SUSTAINABILITY OF ENERGY SUPPLY AND RESOURCES IN NSW

Organisation: Yass Earthmovers

Date Received: 8 August 2019

Yass Earth Movers has concern and Objects to the Rye Park proposal of the following reasons,

Document Path: C:\GIS\Development_Sites\NSW\RyePark\Maps\Working\RP_037_TurbineLayout_MBA3P.mxd

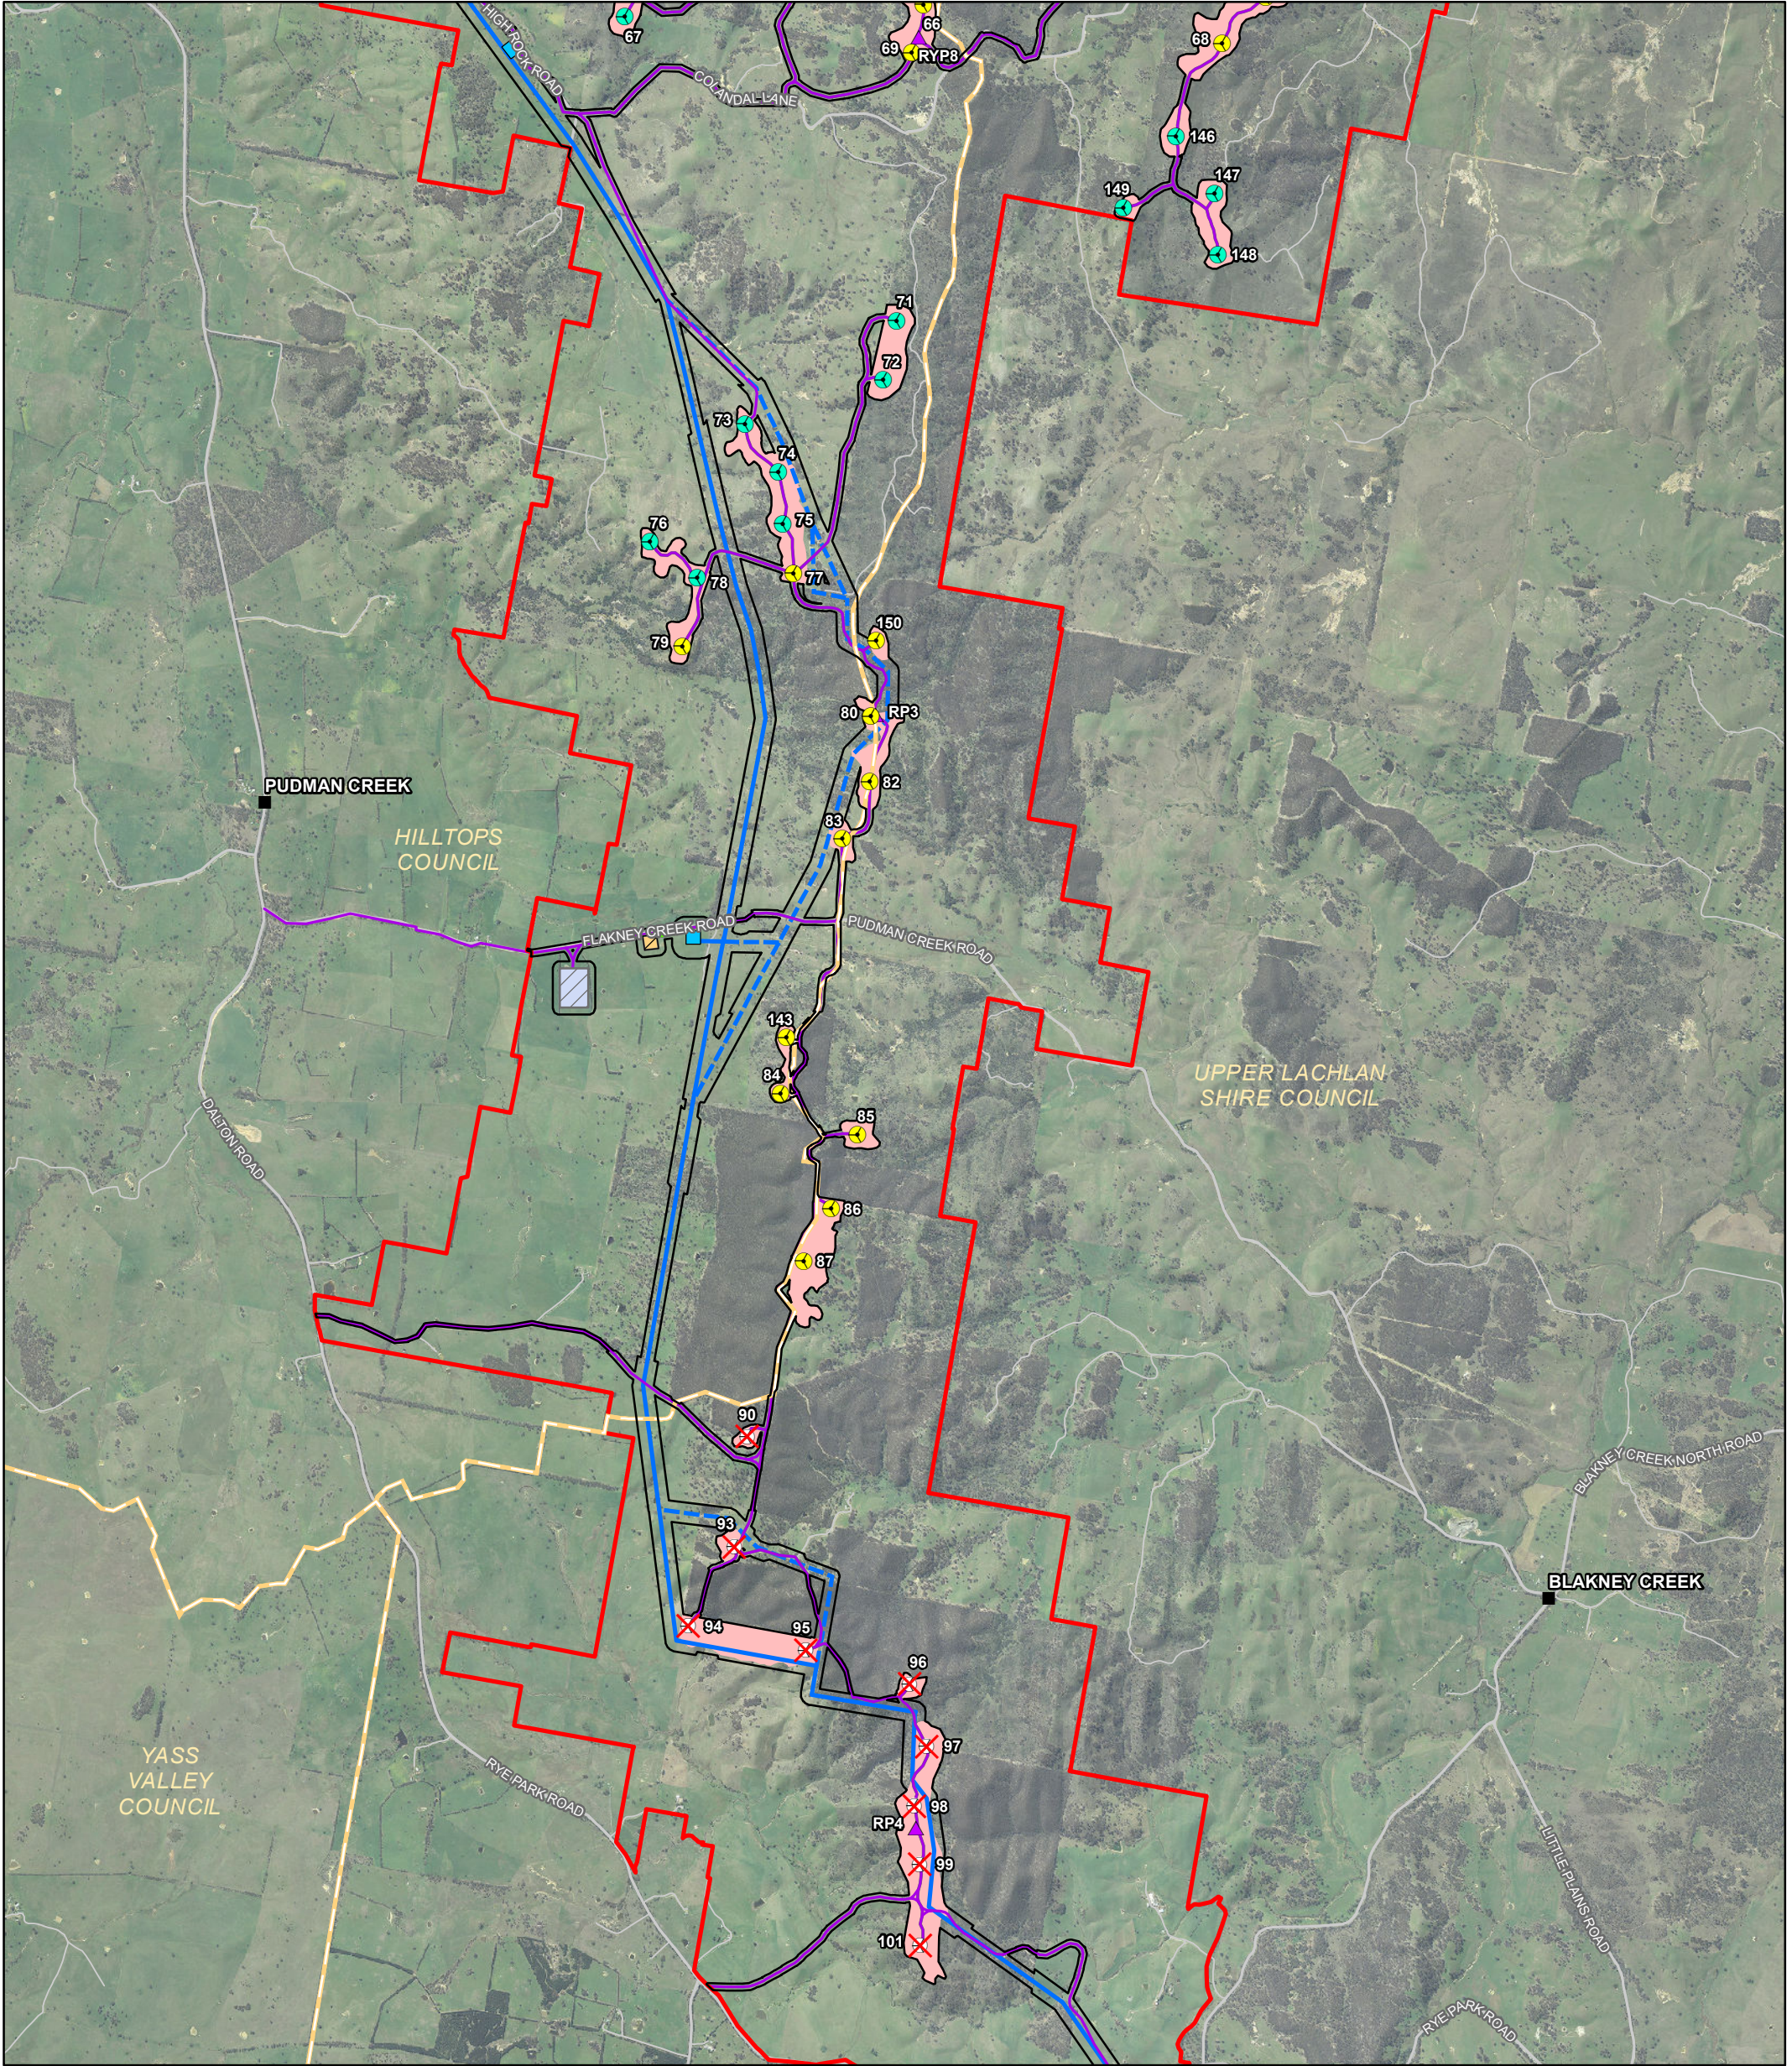
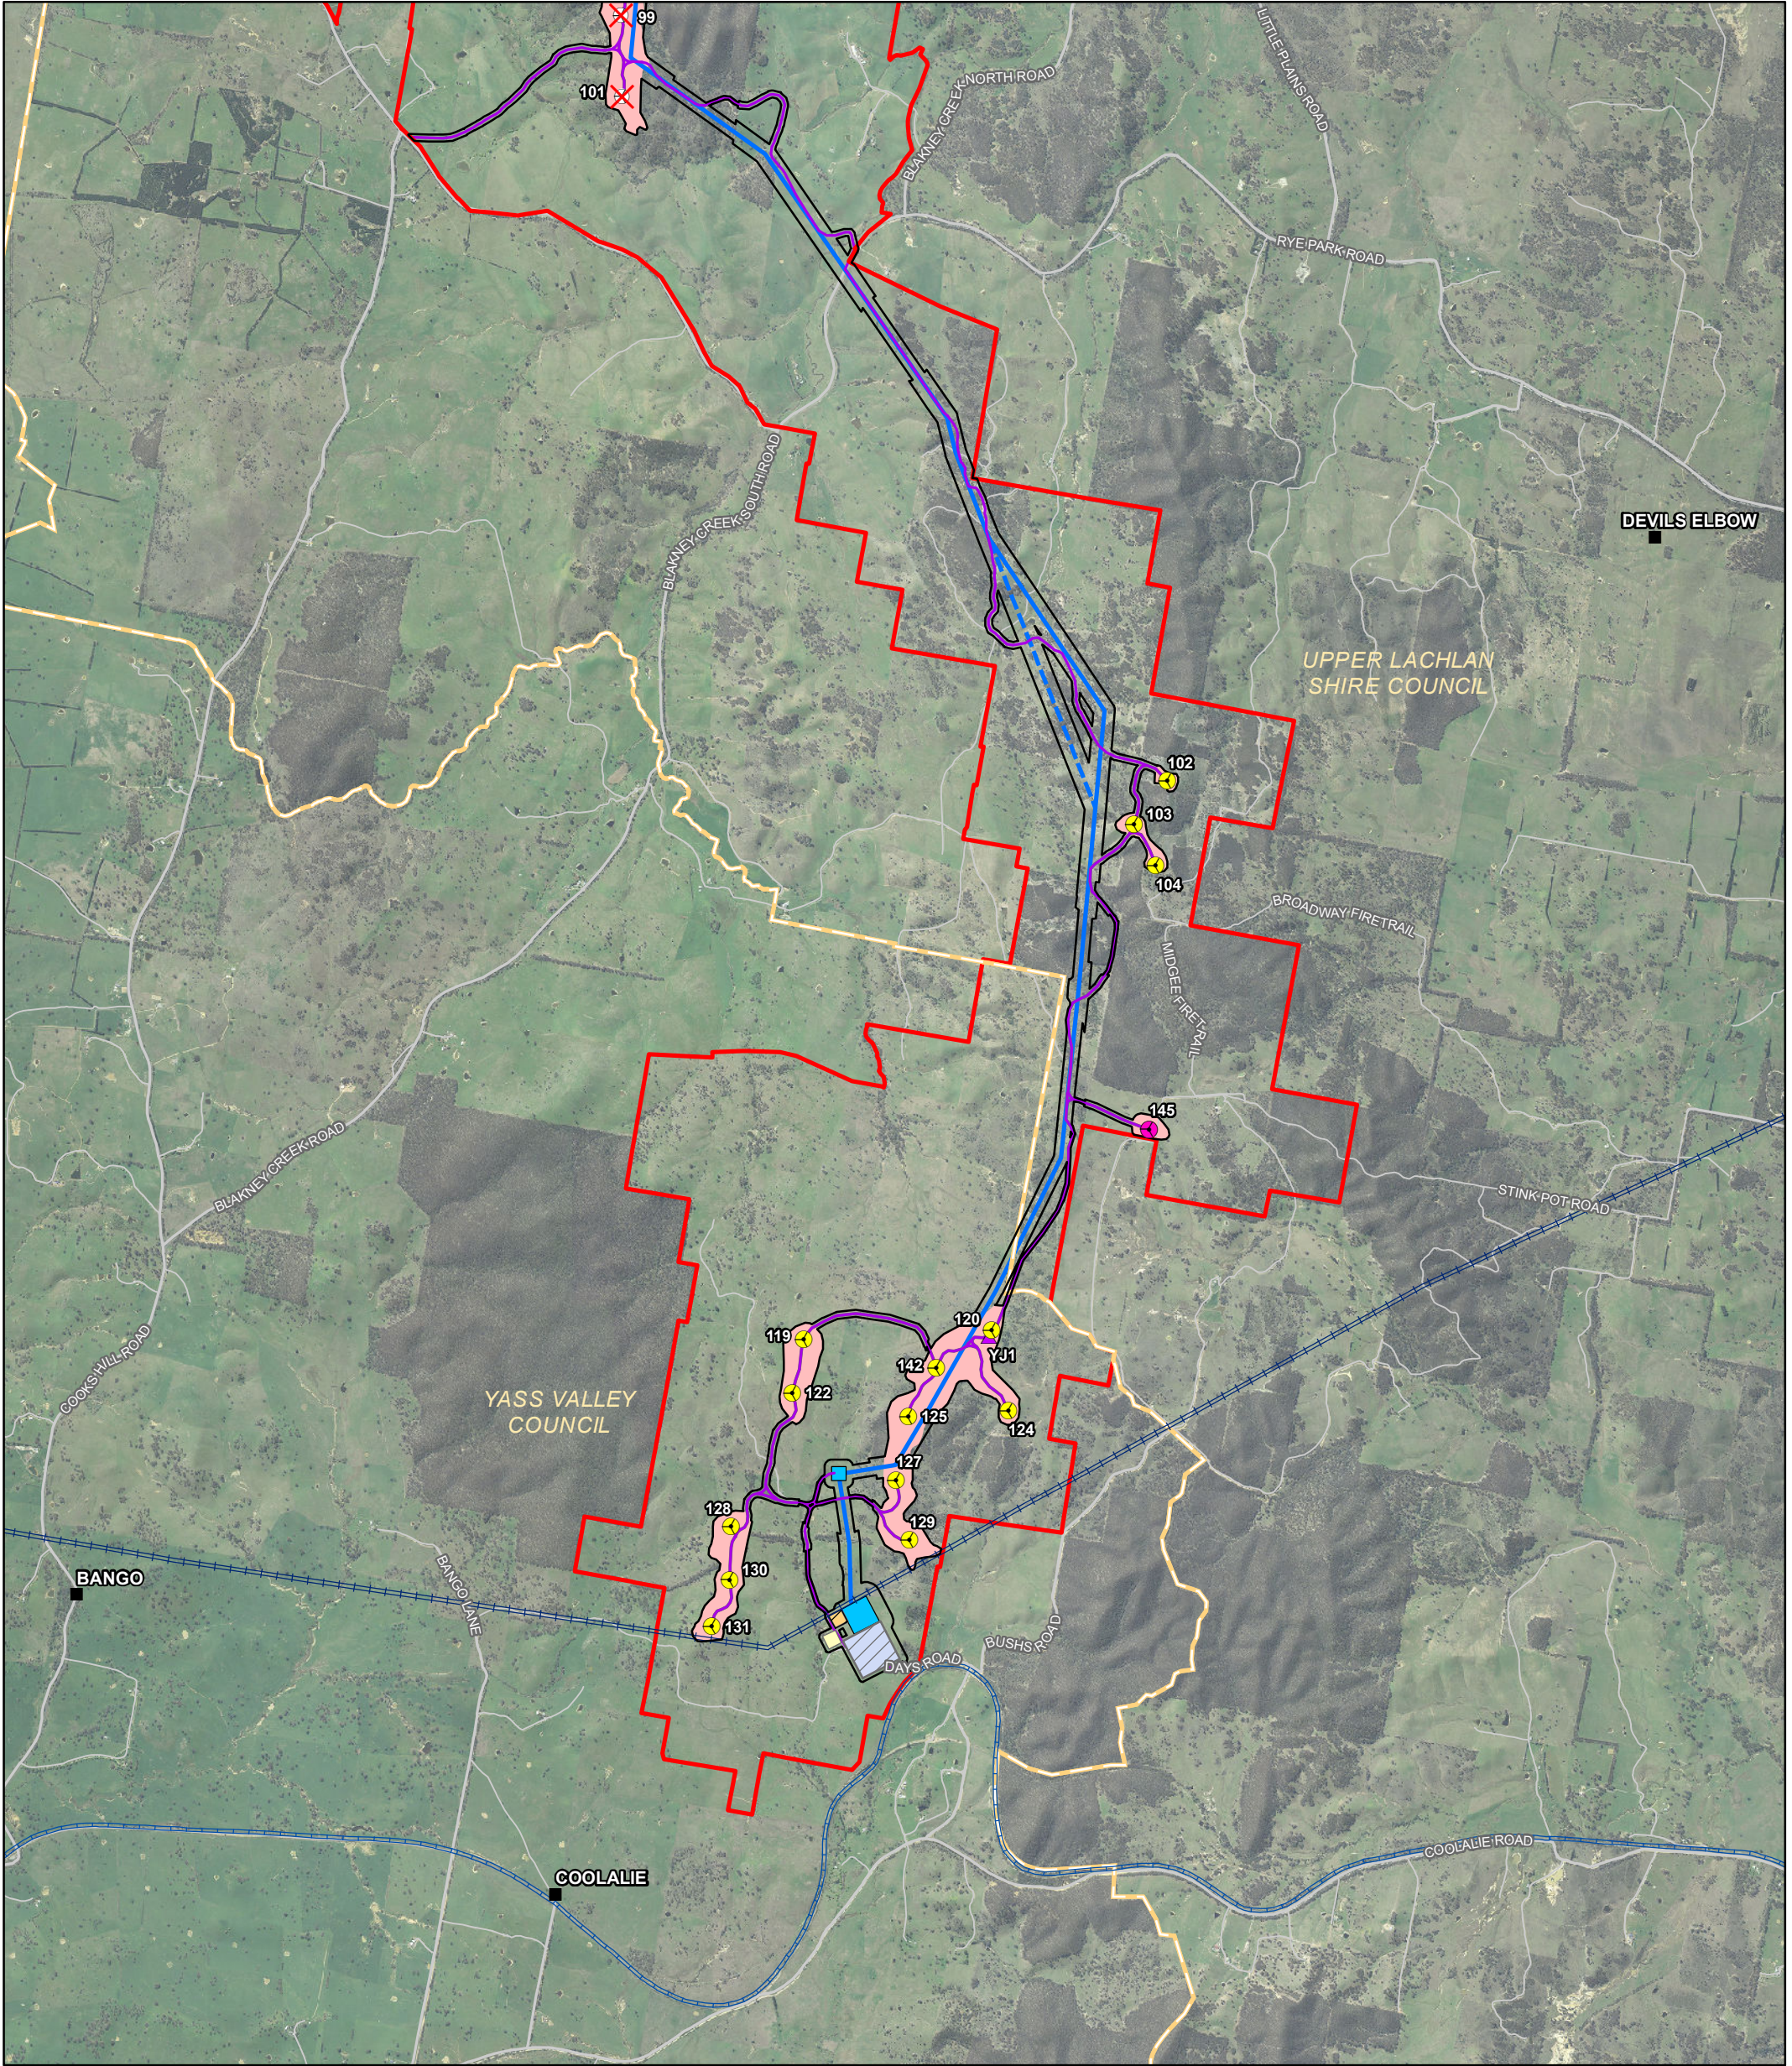
The Yass end batch plant is on the other side of the main rail line between Sydney and Melbourne, this means all material will have to pass over the main line to the batch plant including water and then back over to distribute to the tower locations. This will be a very high risk process that should on it own be rejected.

- On the Trust Power web site it states footing for the tower is 21m diameter, 3.2m deep = $1110\text{m}^3 \times 109 = 120,990\text{m}^3$ of concrete = 24,198 truck loads
- Truck and dogs 4,033 @ 30T each to bring material in
- The locals will get no benefit from this as they are setting up their own batch plant onsite.

- Council doesn't have enough water during summer to grade the dirt roads in the Shire let alone sell our water supply.
- 8ML is proposed
- Water in concrete allowance alone = 18.15ML
- 1 x water truck @ 14,000L x 8 loads per day x 90 weeks (2 years) = 10ML est 5 water trucks = 50ML + 18ML = 70+ML
- I estimate it will be way over 100ML, Who is the estimator ??
- Do we have the water? No
- Do you want water restrictions? No.
- From Burrinjuck isn't viable
- They are proposing to get it from the new Yass Wier and Boorowa weir. Or put in bores, That's not viable as it will lower the water table and cause even more salt issues !
